DECLARATION OF JOHN C. HALEPASKA IN SUPPORT OF  
TEXANS FOR A SOUND ENERGY POLICY'S  
PETITION TO INTERVENE AND CONTENTIONS

# **EXHIBIT D-1**

**Subject:** Summary of Contentions, Exelon's ESP Application for the proposed Victoria County Station Site

As requested by Texans for Sound Energy Policy (TSEP), John C. Halepaska and Associates, Inc. (JCHA) reviewed the Early Site Permit Application (ESP) for the Victoria County Station (VCS) Site. The permit was submitted by Exelon Nuclear Texas Holdings, LLC (Exelon) to the US Nuclear Regulatory Commission (NRC) on March 25, 2010, in accordance with 10CFR52 with a requested permit duration of 20 years. This application was submitted to replace the previously submitted combined license application (COLA) to construct, possess, use, and operate two Economic Simplified Boiling Water Reactor (ESBWR) units, referred to as Victoria County Station (VCS), units 1 and 2 which was previously submitted by Exelon on September 2, 2008.

Figure 1: Known surface faults as well as know oil and gas wells on VCS site and vicinity.

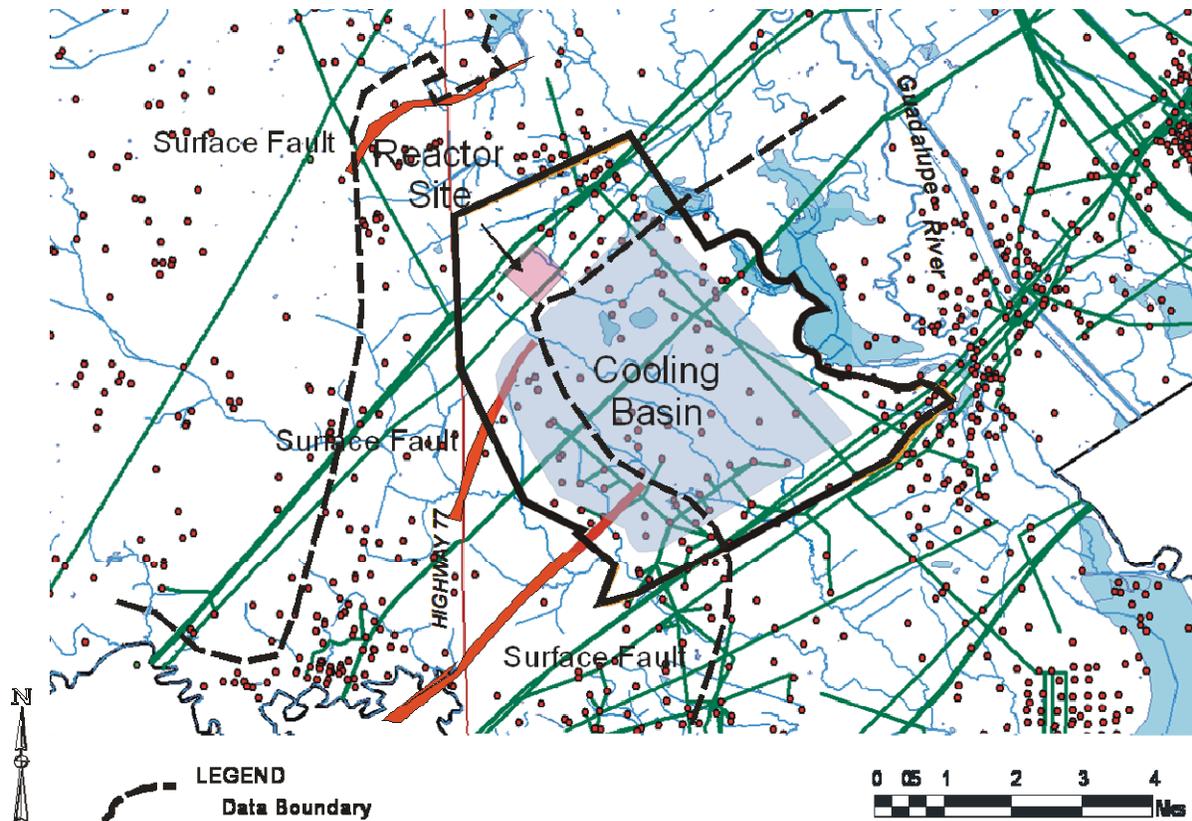
Growth faulting is prevalent in the Texas gulf coast region of the United States. There was no mention in the ESP of a link between growth faulting and the potential for increased seepage from surface waters. Studies by Losh et al and Zeng et al suggest that fluid migration along growth faults is common. These faults could add to the already high seepage rates expected from the VCS site, and help to aid in the distribution of toxic chemicals to the surrounding environment. It is known that surface faults are present in and around the VCS site (Figure 1). Exelon should be required to investigate growth faulting in the vicinity of the VCS site, as well as investigate the relationship between growth fault propagation and seepage loss from the cooling basin impoundment.

Figure 2 - GBRA Historic Diversion Rates Plus Estimated Exelon Diversion Rates

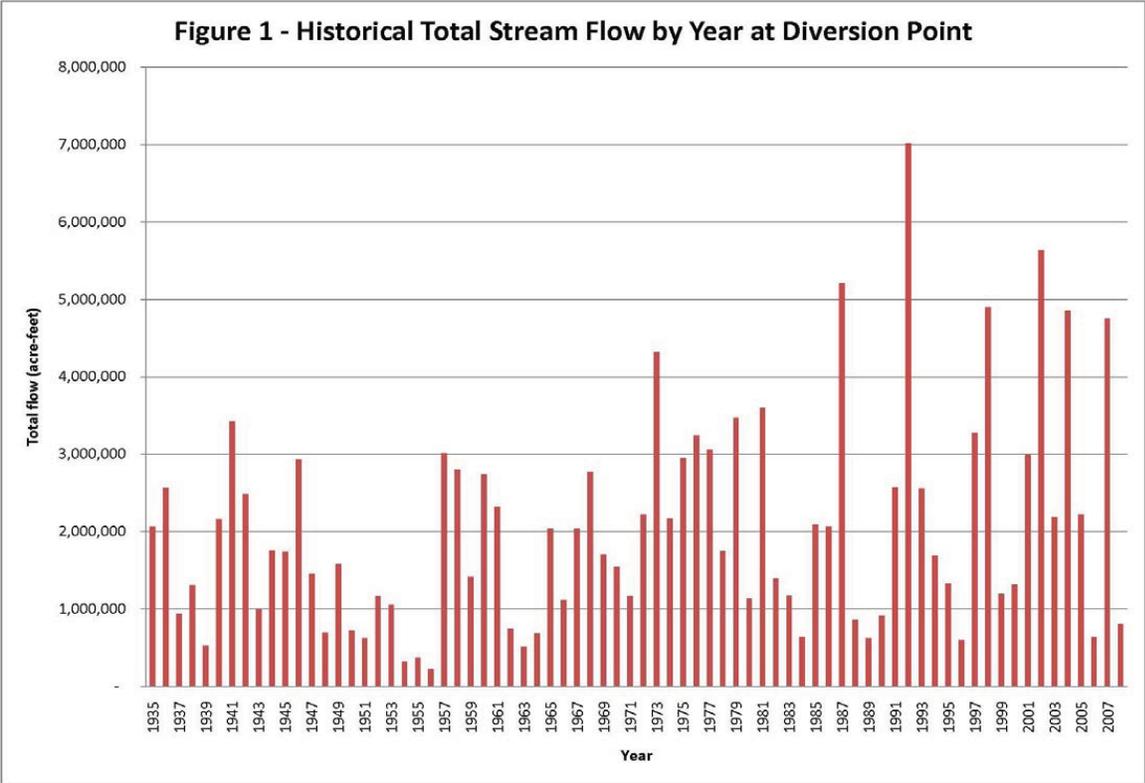
Table 2 and Figure 2 show a combination of the monthly historic GBRA diversions from 1991 through 2008, and the proposed diversion rates for the VCS, in acre-feet. Table 3 and Figure 3 compare the proposed diversion rates listed in Table 2 to the measured streamflows at the Saltwater Barrier. In summary, the proposed diversion rates will result in a 14% average reduction in streamflow to the Estuary.

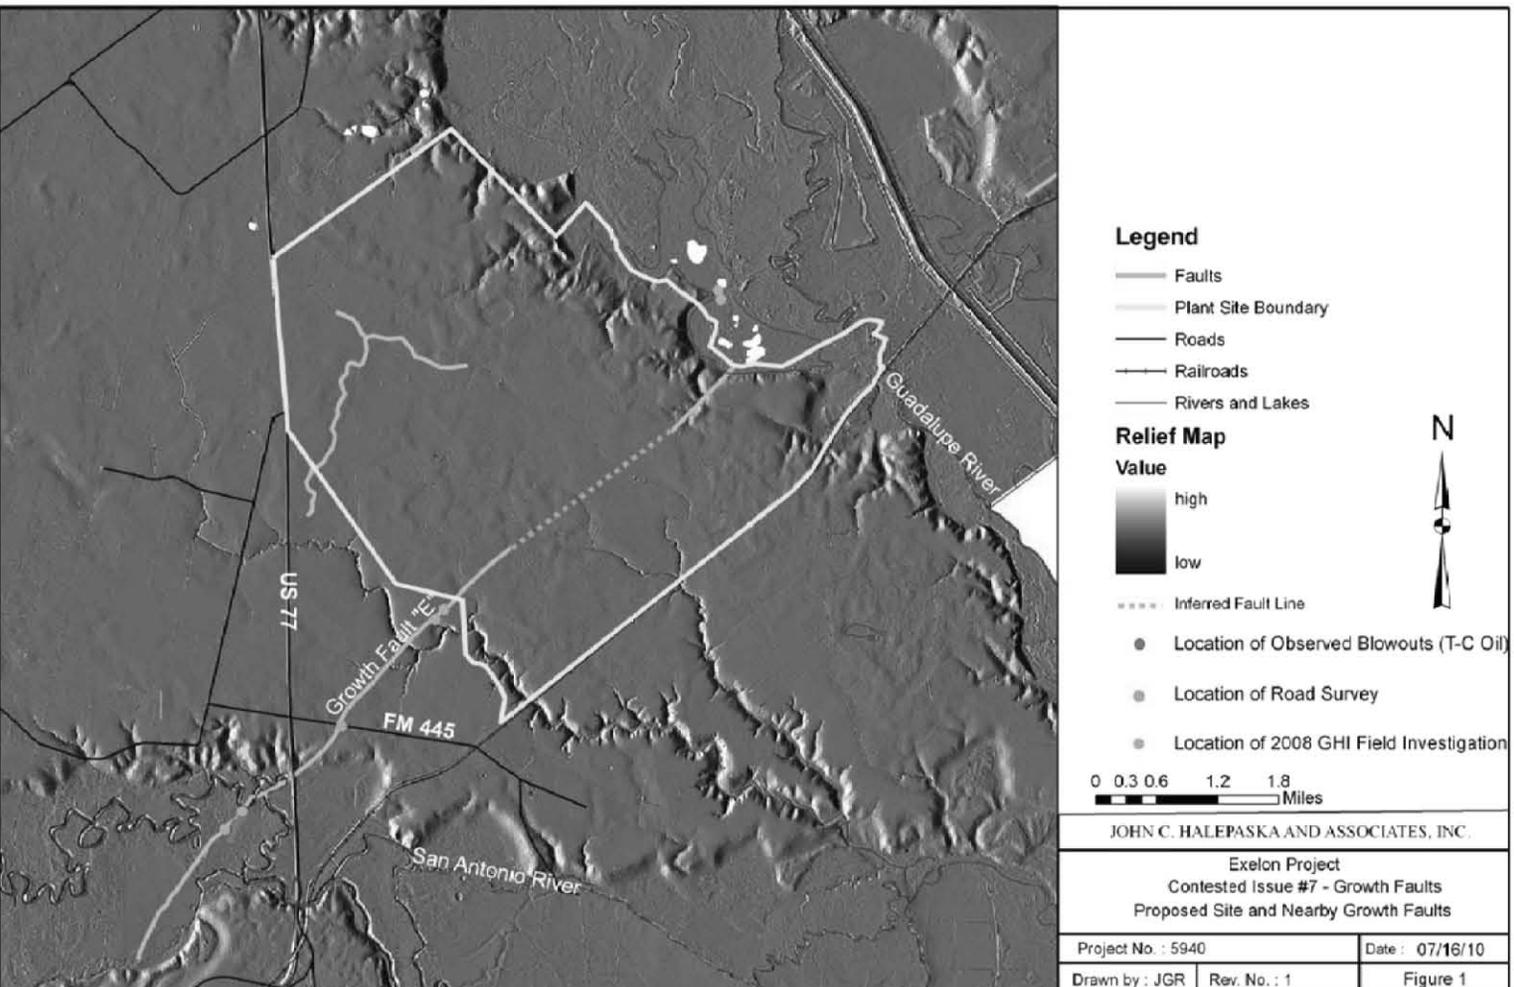
Figure 1 shows the proposed VCS site, and documented growth faults. JCHA has observed the growth fault named in the SSAR as "Growth Fault E" where it crosses McFaddin Road (FM 445). There is a noticeable dip in the road at this point.

Figure 2 - McFaddin Road (FM 445) Looking ENE at Growth Fault

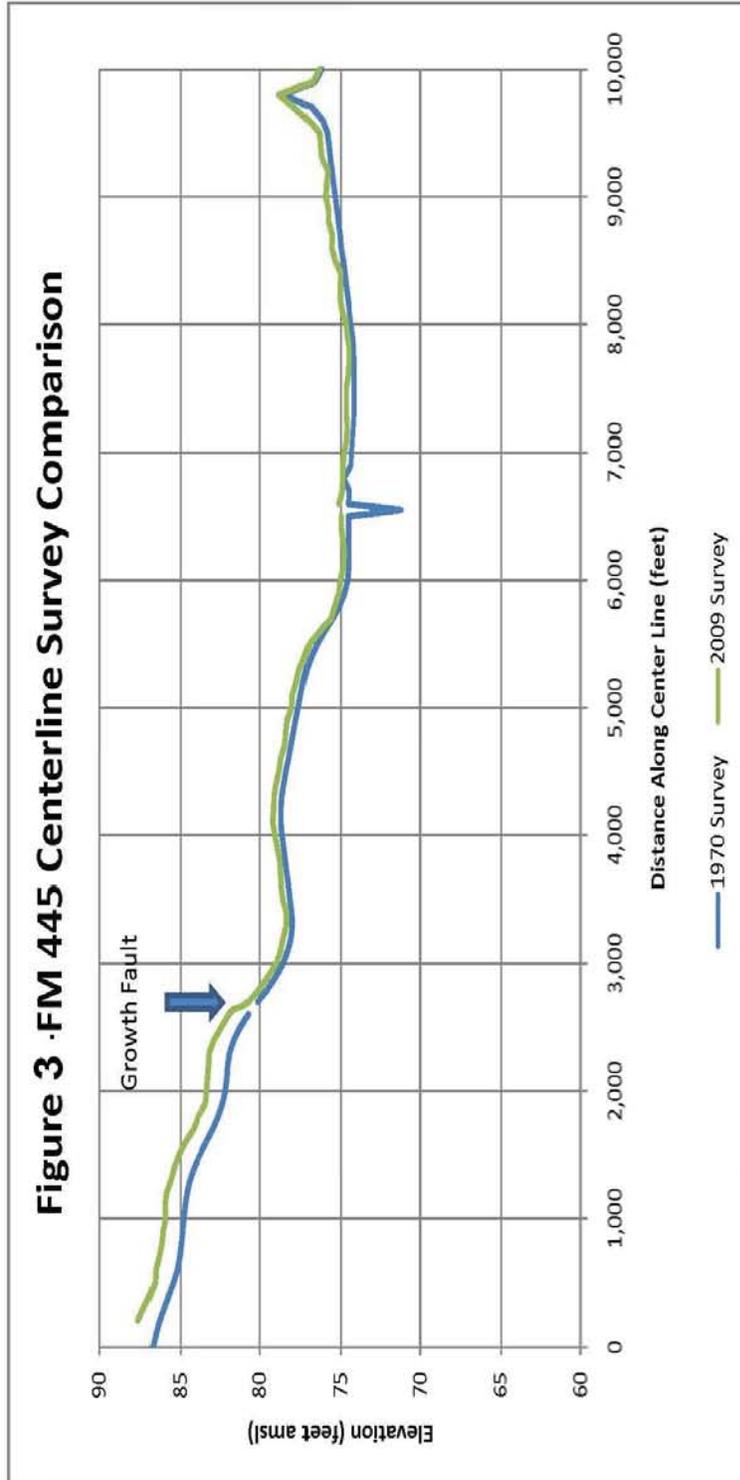
Figure 2 shows a photograph of the growth fault where it crosses the road. JCHA obtained the survey data from when the road was constructed in 1970, and found that the road was not built with a dip in it. It then stands to reason that the dip has occurred since 1970, and any measurable offset could be primarily attributed to growth fault movement. JCHA hired a local surveyor, CivilCorp, LLC, to resurvey the road using the same survey points as those used from the road survey in 1970, and some additional points across the area of the growth fault. This survey was performed on March 10, 2009.

The results of the survey (Figure 3) show a dip of approximately eight inches, or 0.67 feet. Assuming that this activity happened at a uniform rate over the course of the last 39 years, the resulting movement rate of this growth fault would be 0.2 inches per year, which is approximately 1,000 times larger than the rates estimated in the SSAR (0.00005-0.0005 in/yr).

Figure 4 - Trench Cross Sectional View

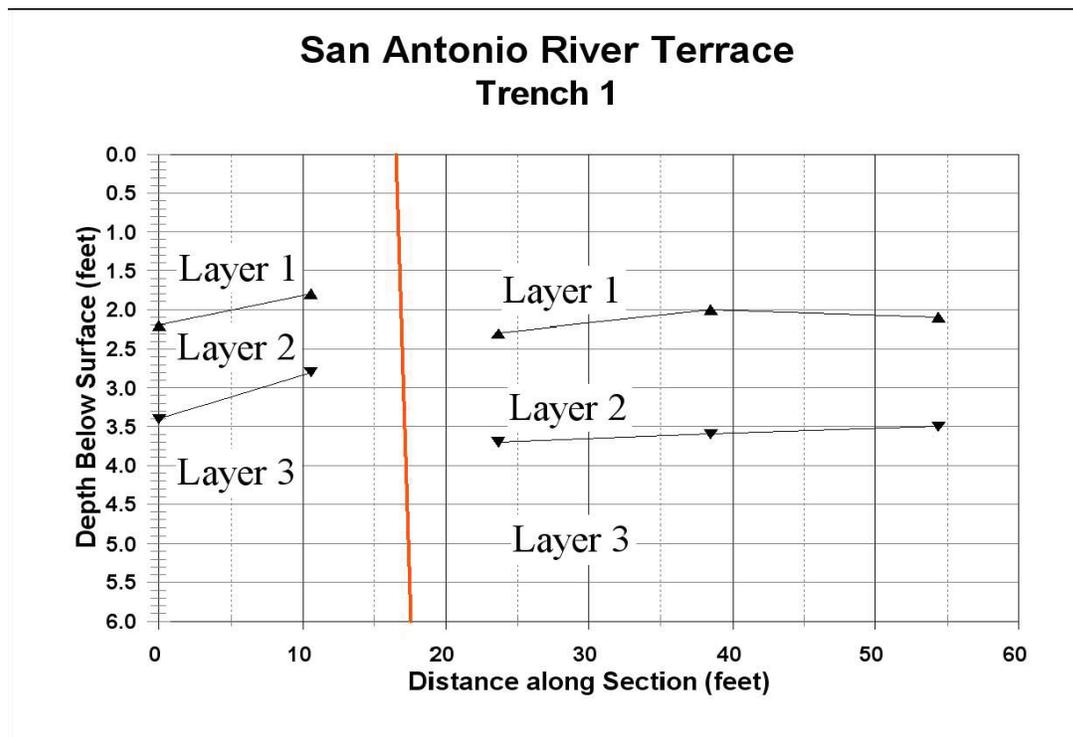
JCHA contracted GHI to observe the excavation of a series of trenches just North of the San Antonio River in the vicinity of the VCS site (2008, Geo-Hydro, Inc.). These trenches showed a visible offset in near surface stratigraphy of at least 6 inches (Figure 4). Although dating of the offset was not performed, this corroborates that there has been movement across faults in the VCS area.
